Adequacy Review No. 2 Response

RE: Goodrich Pit, 112c Application Number 2019-005 Adequacy Review No. 2 Response

Goodrich Pit

Pre-Mining Map

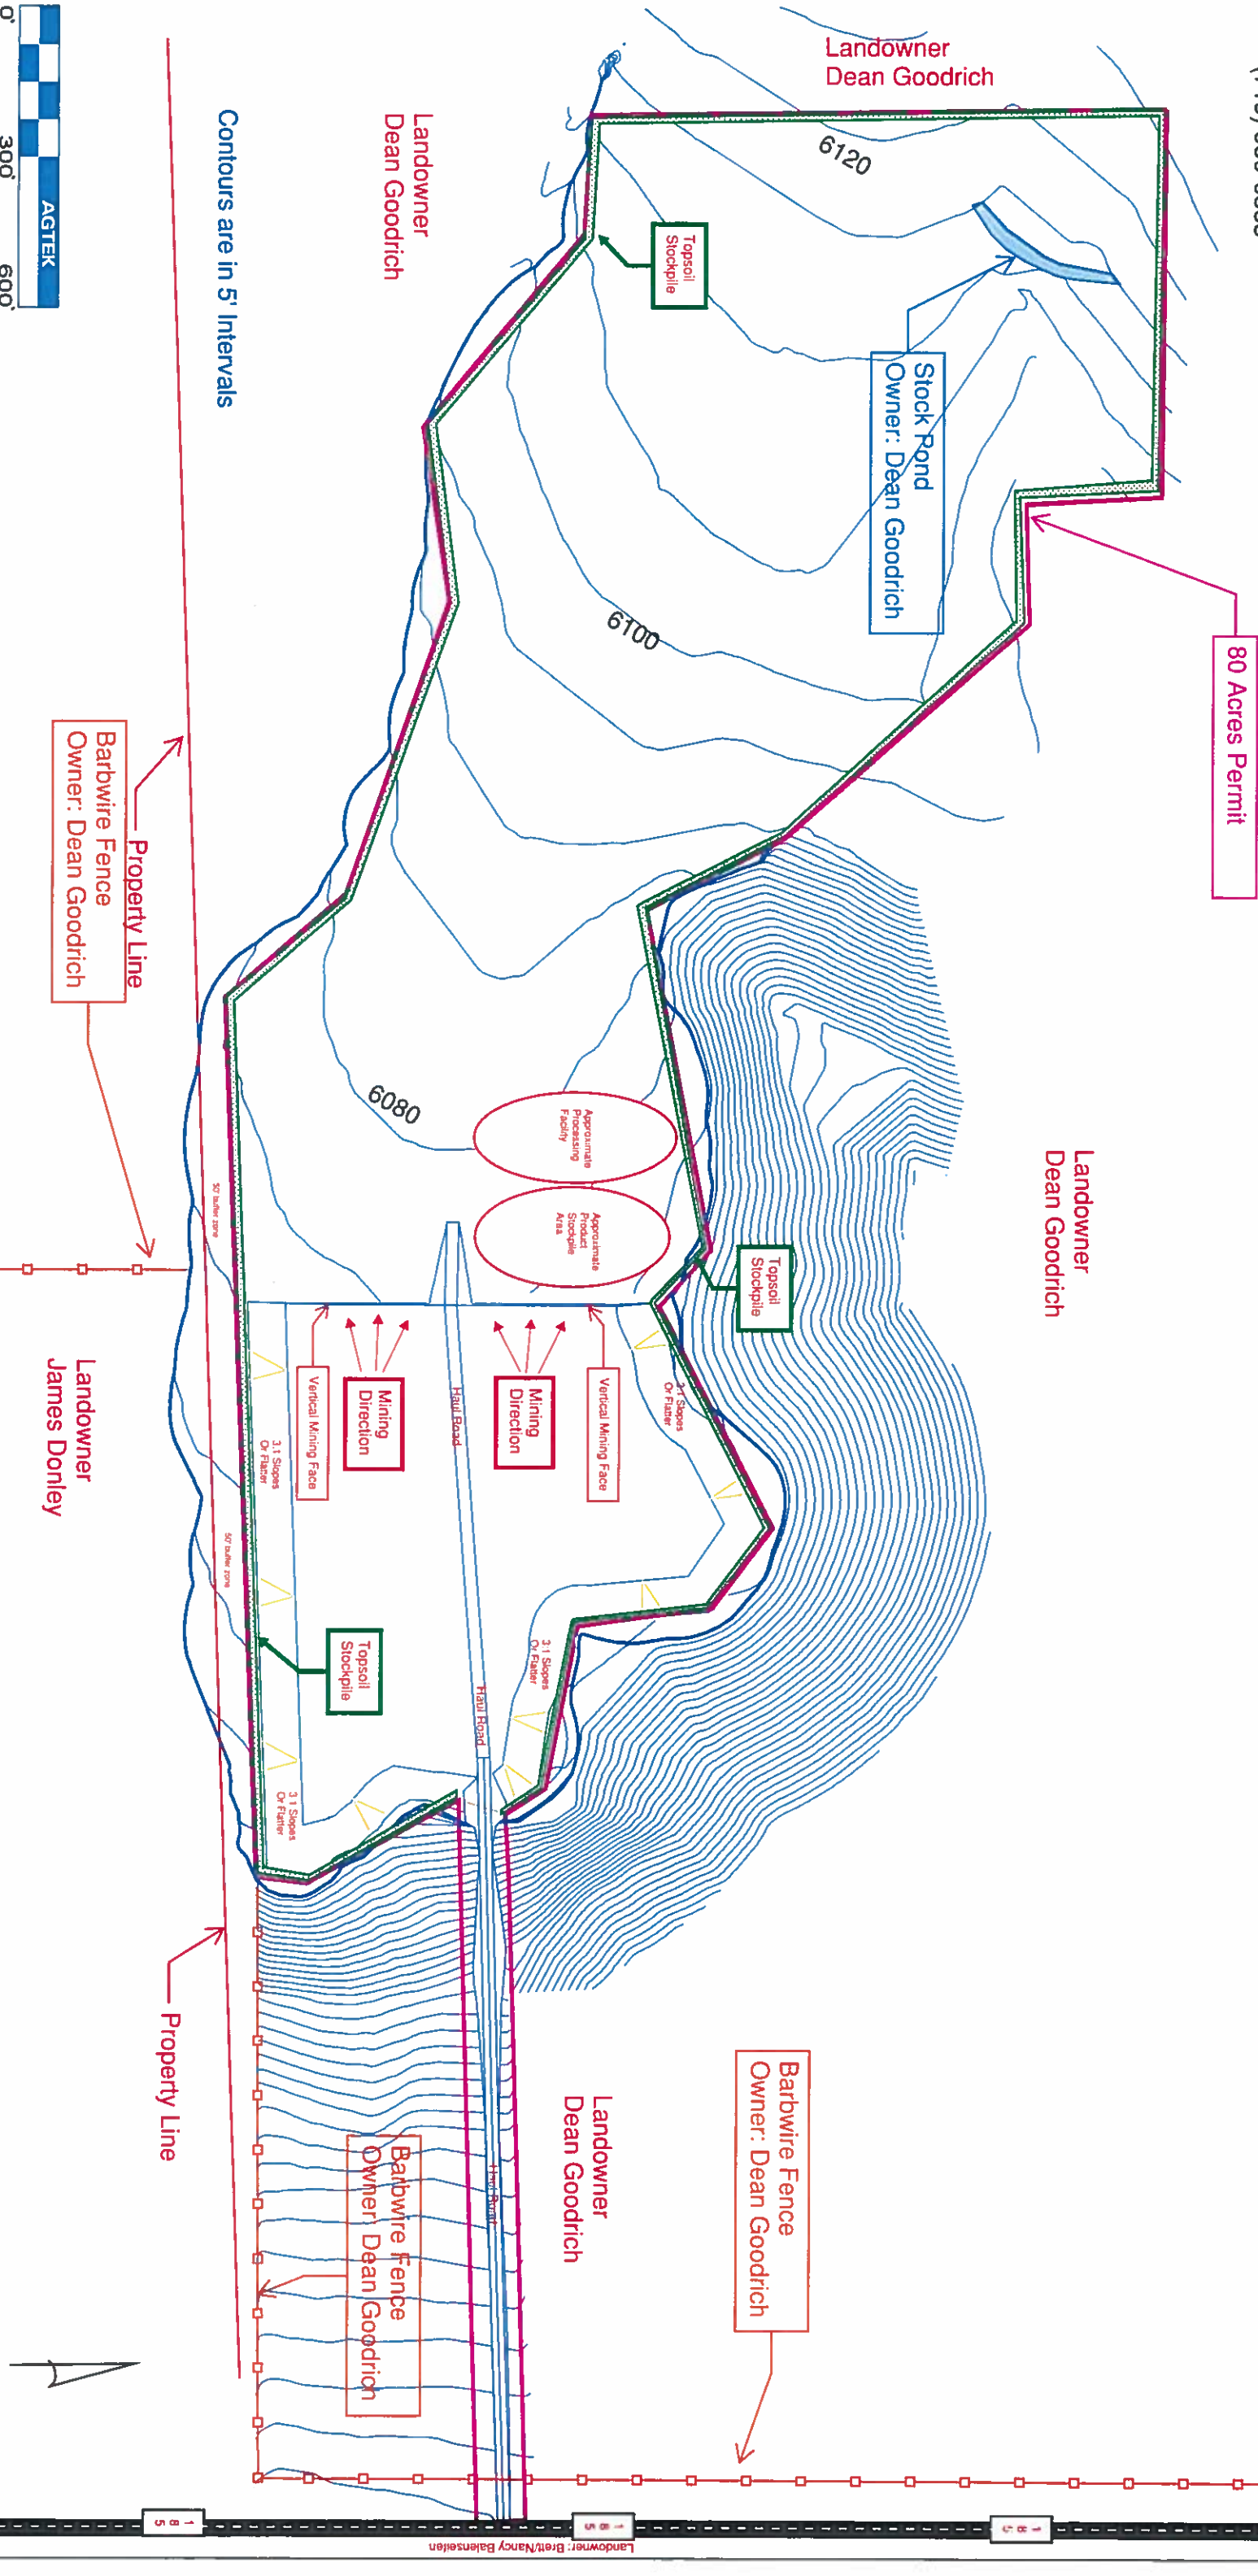
Thank you for your review of our application documentation. Regarding number 1, we have attached a revised Pre-mining map with the contours labeled. To answer number 7, Fremont Paving is committed to compensating the owner if any damage is done to the stock pond.

Contours are in 5' intervals
